BIDDER QUESTIONS LOG

PROJECT: Montgomery College Catherine & Isiah Leggett Math and Science
OWNER: Montgomery College
ARCHITECT: SmithGroup
PRINT DATE: 4/13/2020

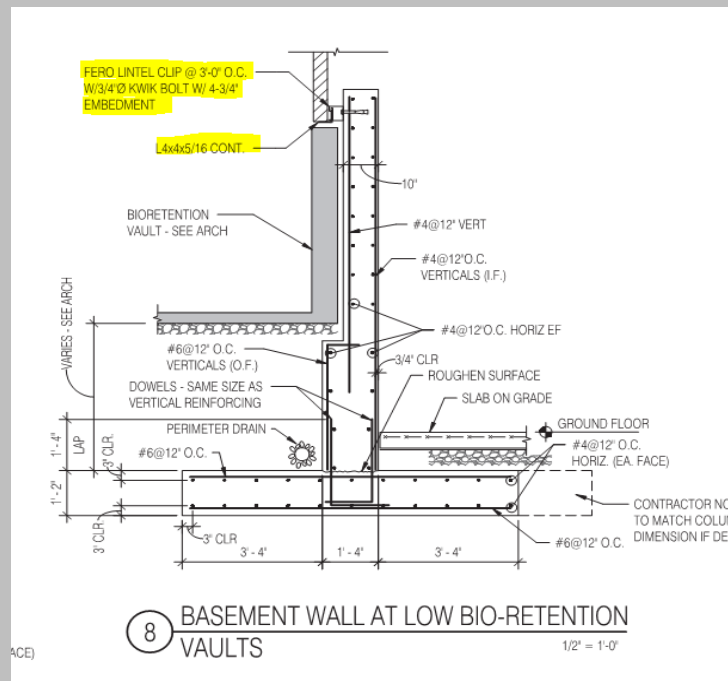
Q: Detail 8/S3.8 and similar details shows a continuous angle and Fero lintel clip, are these in the misc. metals scope?

A: This will be captured in the misc. metals scope of work, bidding at a later date.

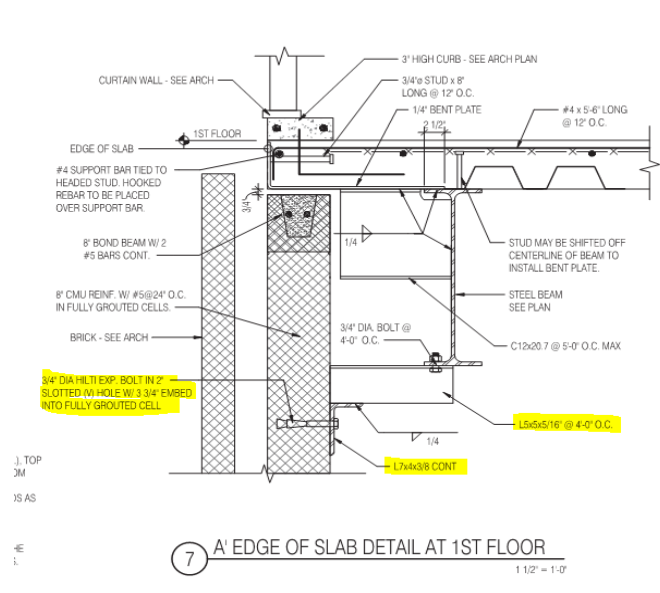
Q: Detail7/S3.4 and smiliar details show and continous angle bolted into the CMU with the L5x5 tying back to the beam. Are these in the misc. metals scope?

A: This will be captured in the misc. metals scope of work, bidding at a later date.

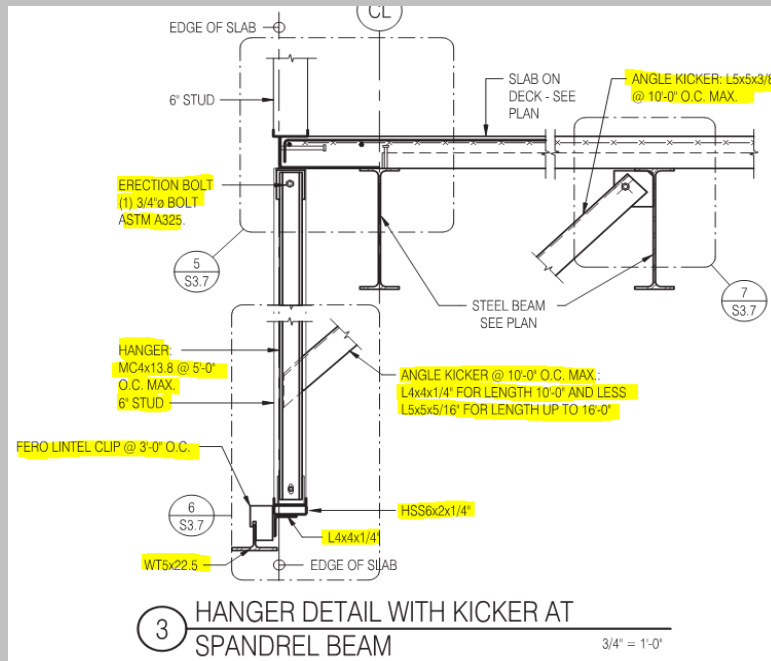
Q: S3.7 shows the masonry hanger details. For this detail and similar details, which items fall into what scopes?

A: This is to be captured in the structural steel scope of work (this bid package).
